Technical Service Bulletin: tsb100744

Released Date: 16-Mar-2009

New Two Piece Fuel Manifold

One Piece Fuel Manifold

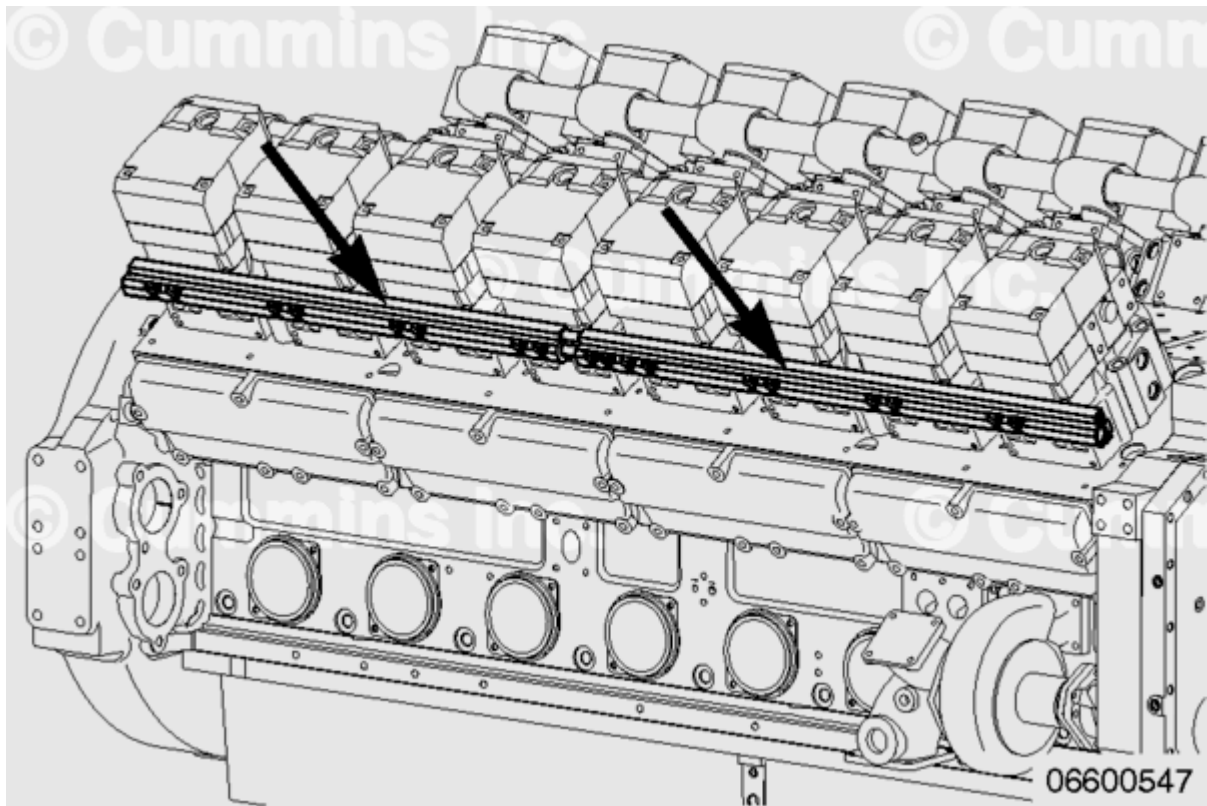
The damage mode associated with the present fuel manifold is a fatigue crack that propagates from close to the mounting hole at the bottom edge of the manifold.

When a one piece fuel manifold fails, it is recommended that the fuel manifolds on both banks be replaced with the two piece manifold.

Two Piece Fuel Manifold

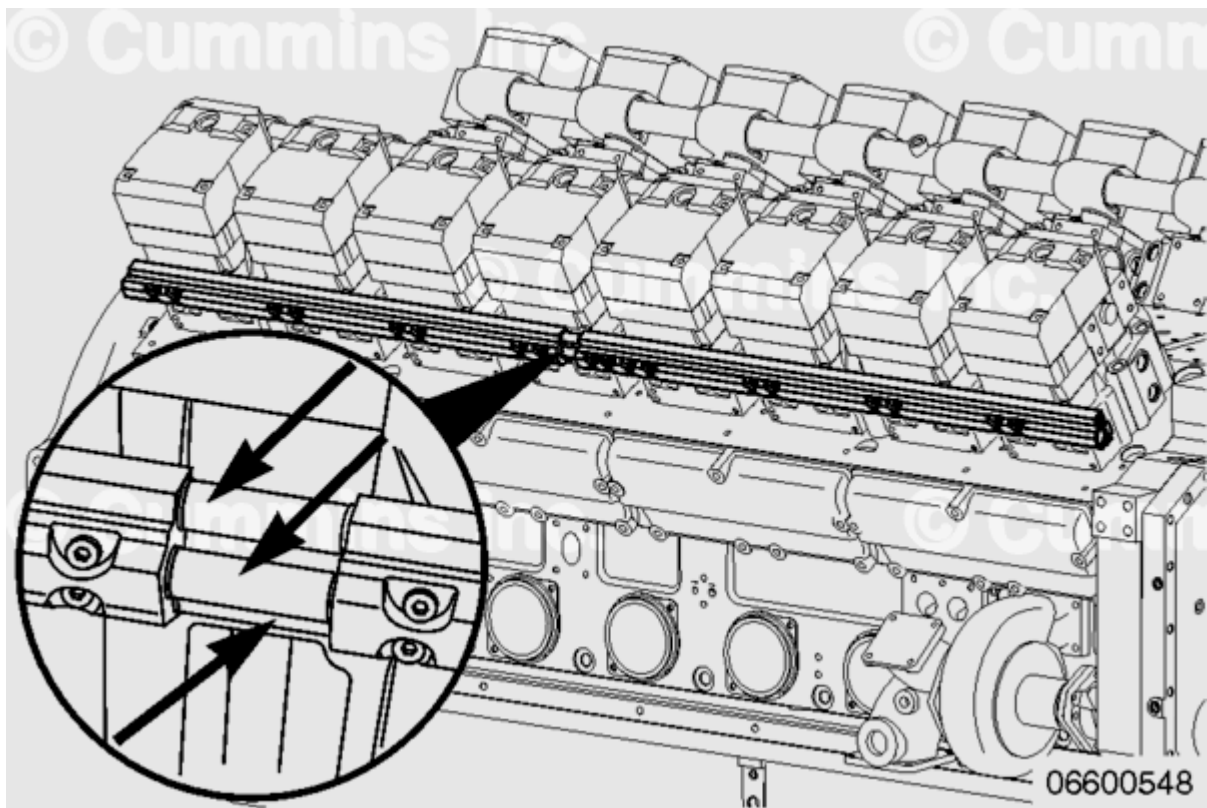
The two piece fuel manifold will reduce motion between fuel manifold(s) and gasket(s).

Two Piece Fuel Manifold Transfer Tubes Detail

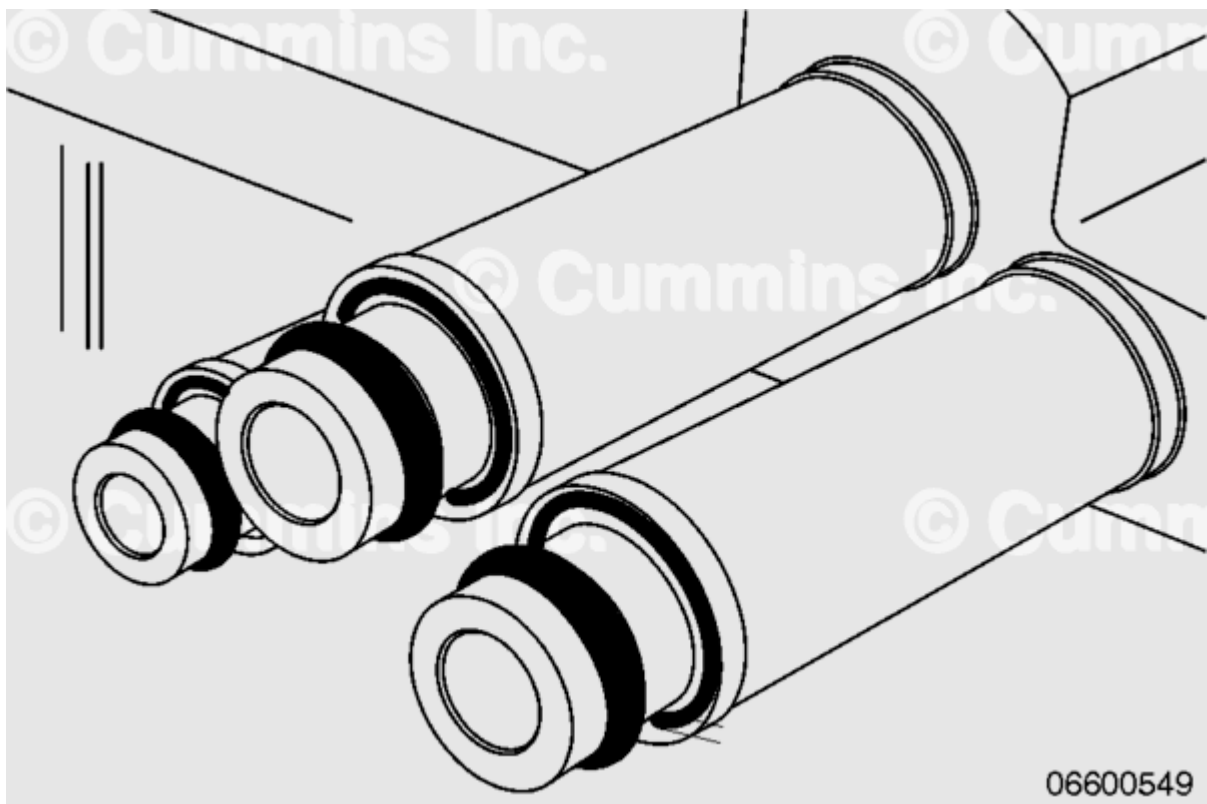
The two piece fuel manifolds are connected by three fuel transfer tubes with non reusable o-rings.

Fuel Line Shield

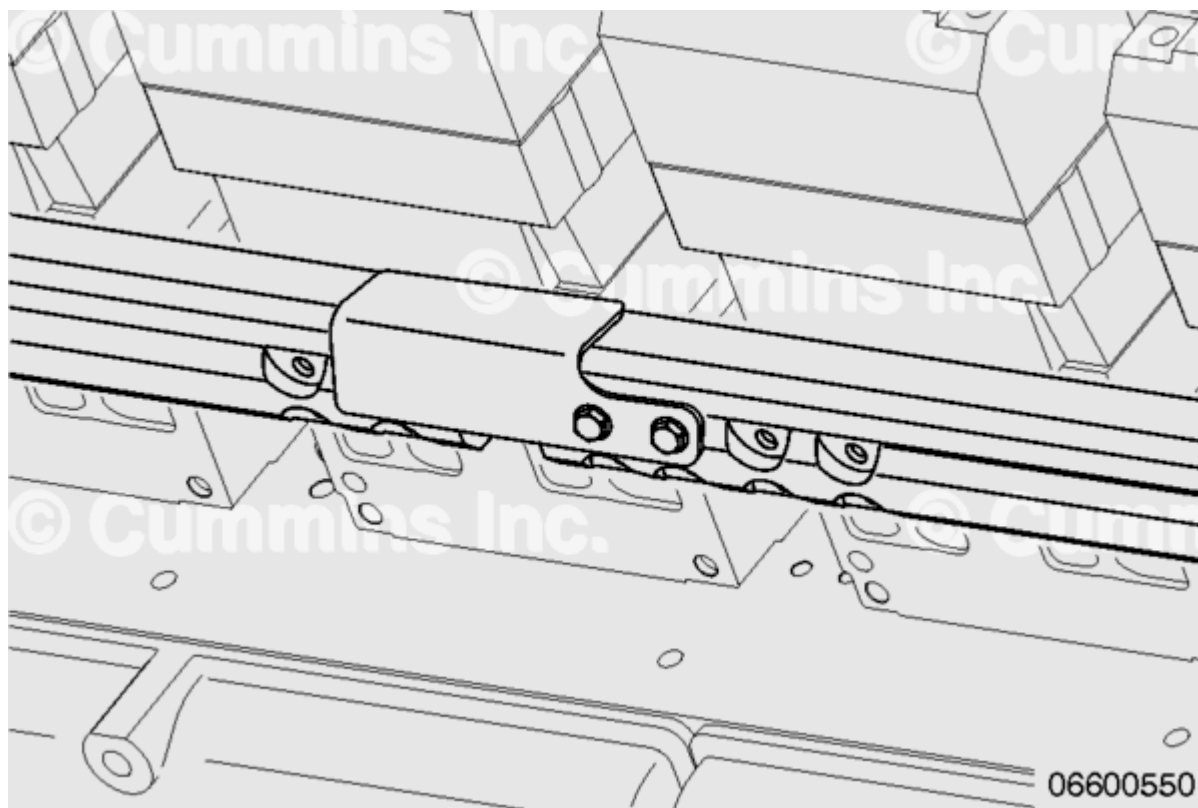
The transfer tubes are protected by a fuel line shield as shown below.
